Commentaires des résidents – PPCMOI 500 Claremont :

Comments from residents – SCAOPI 500 Claremont:

A few comments about the second SCAOPI process for 500 Claremont:

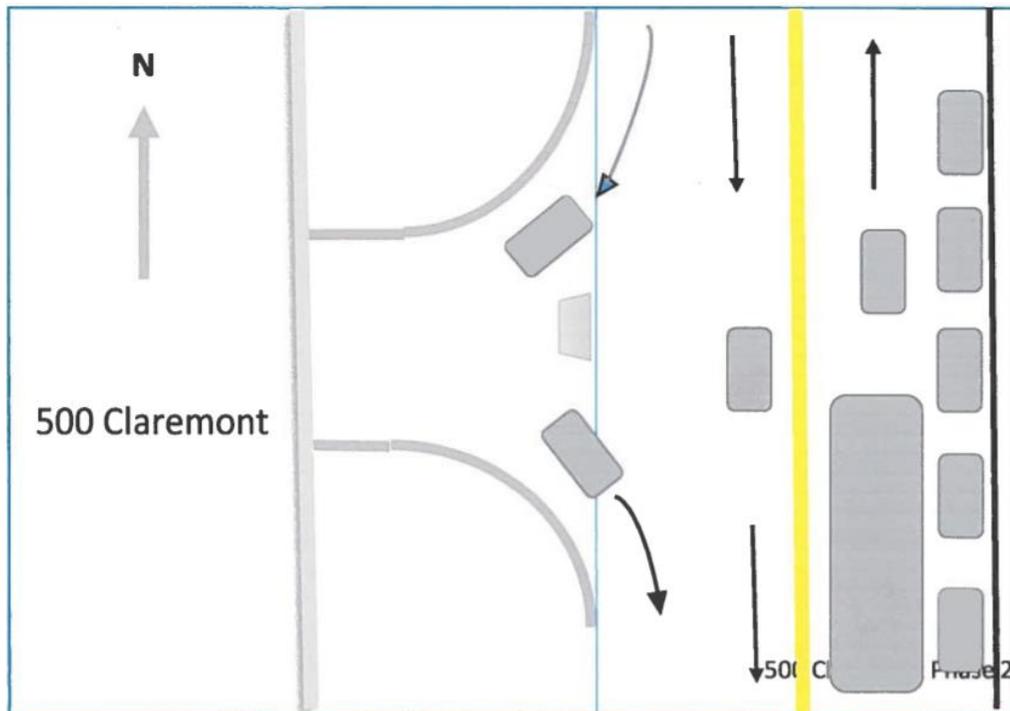
Yet again, this is a request for change to the dangerous design of the parking entrance / exit to a safer one. According to the December 2018 proposal, 43 cars will enter and exit in a haphazard way, an increase of 10. I propose that the entrance / exit design be changed now, at this design approval stage, to control the directions of the cars entering and exiting, and so reduce the possibility of accidents, and injuries to pedestrians. The sketch below shows one design which would reduce the risks to vehicles and pedestrians, as follows:

Entrance from north only
Exit towards south only
Median to dissuade illegal directions
